## V2500-D5 SERIES PROPULSION SYSTEM NON-MODIFICATION SERVICE BULLETIN

This document transmits Revision 1 to Service Bulletin EV2500-72-0501 and Revision 1 to the Supplement

# V2500-ENG-72-0501

NON-MODIFICATION SERVICE BULLETIN – N2 VIBRATION MONITORING FOR THE HIGH PRESSURE  
TURBINE (HPT) STAGE 2 AIR SEAL

Typical Plot for N2 Vibration Data Analysis  
Figure 1

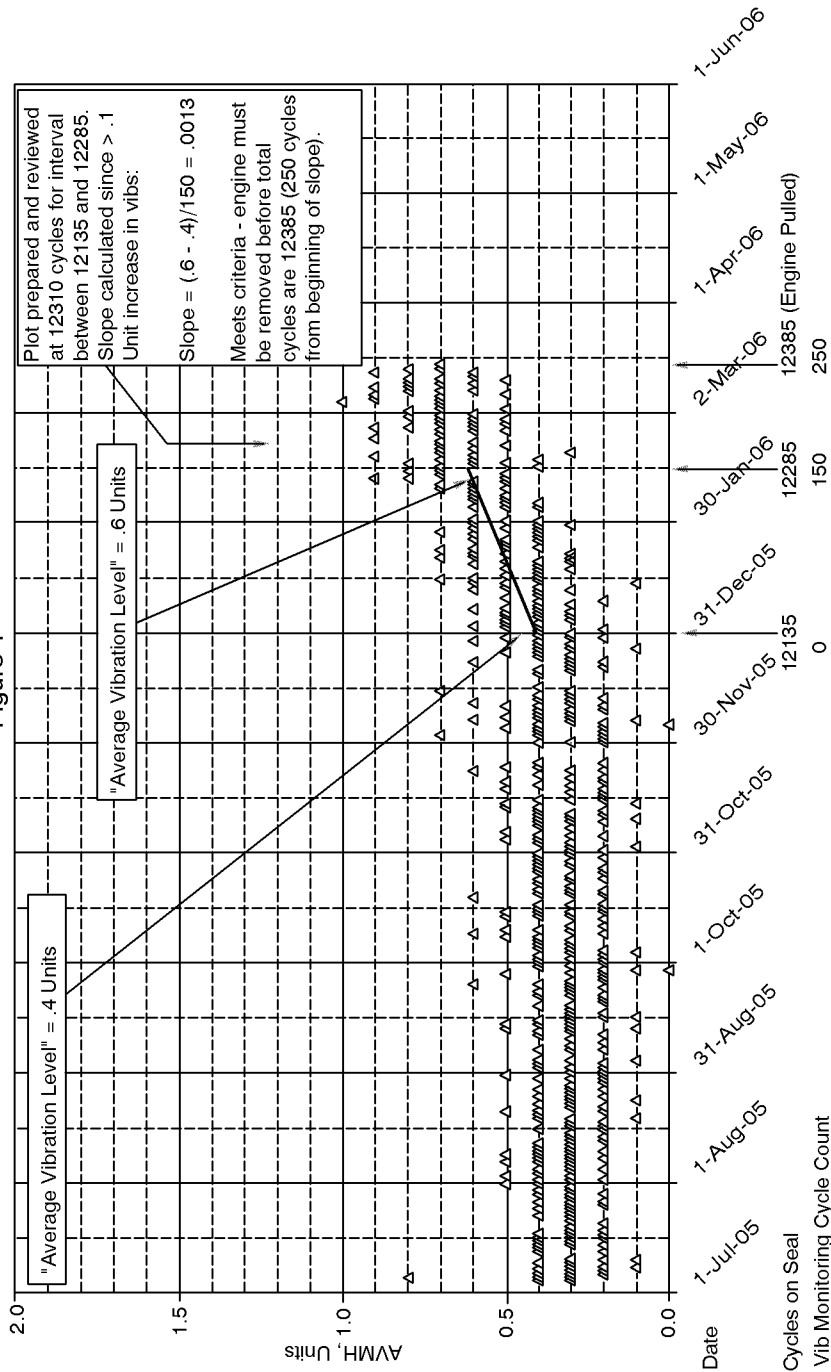
- (4) If there is an increase in vibration of 0.1 units or more, then the slope must be calculated. Since there is scatter in the data, this increase is based on the 'average vibration level' which is the mid-point of the vibration scatter. If the increase is less than 0.1 units engine vibration monitoring should continue per the above steps. The units of the slope are Normalized Units/Engine Cycles (abbreviated NU/cycle). Calculate slope as follows:

**NOTE:** Figure 1 shows a typical vibration plot, the 'average vibration level' and how to calculate the slope.

(a) Slope less than .0007 NU/Cycle: The HPT Stage 2 Air Seal is not suspect of being cracked – the engine can remain in service and vibration monitoring should continue.

(b) Slope is .0007 NU/Cycle or greater and less than .002 NU/Cycle: The HPT Stage 2 Air Seal is suspect of being cracked and the engine needs to be removed within 250 total cycles from when the slope began to increase.

N2 Vibration Data  
Figure 2

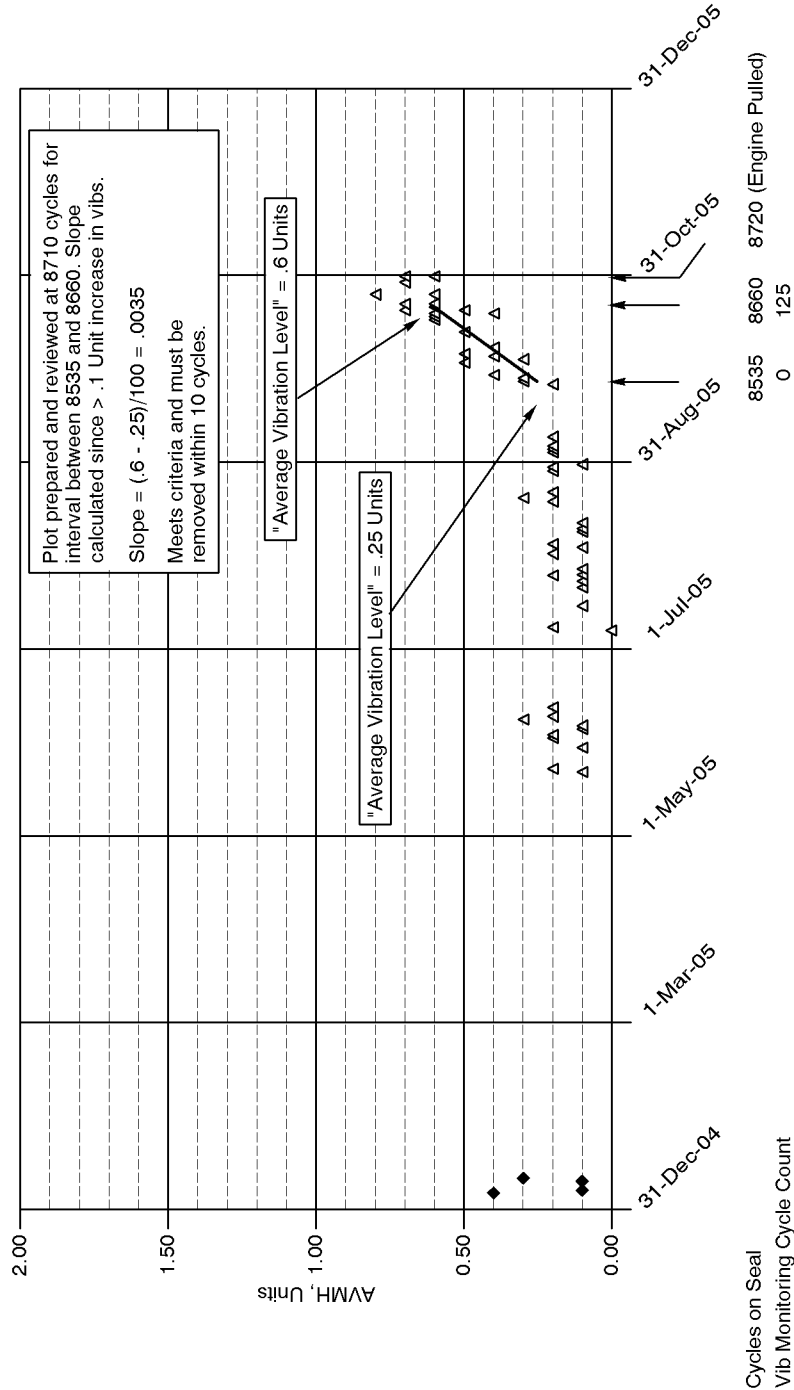
R (c) Slope .002 NU/Cycle or greater: The HPT Stage 2 Air Seal is suspect of  
 R being cracked and the engine needs to be removed within 10 cycles of  
 R when the slope was calculated (Figure 2 shows the plot of an engine  
 R which needs to be removed within 10 cycles).

Figure 3  
Vibration Step Change

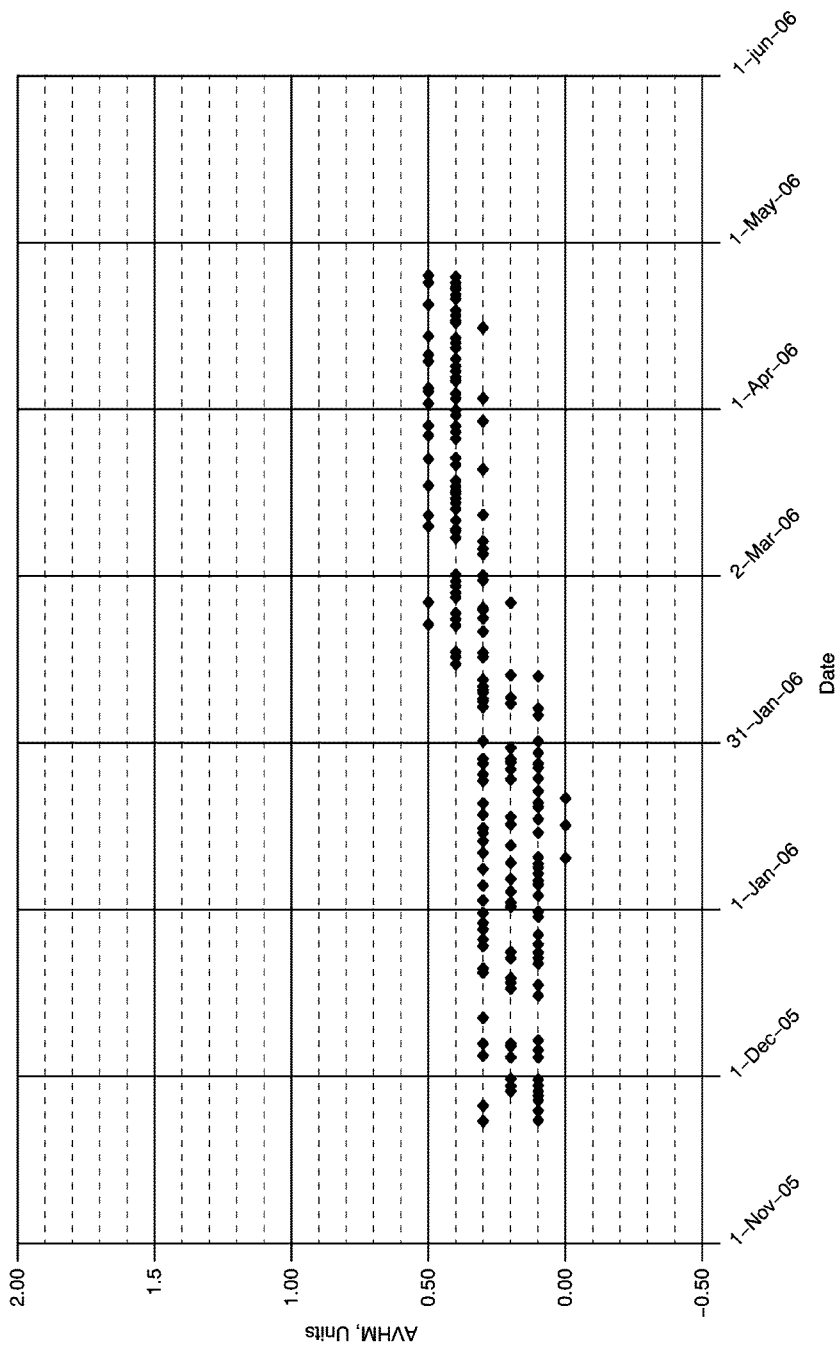
R NOTE: Step changes in vibration are not an indication that the HPT  
 R Stage 2 Air Seal has developed a crack but if observed the  
 R engine should continue to be monitored. Figure 3 shows a sample  
 R of what is considered a step change in vibration.
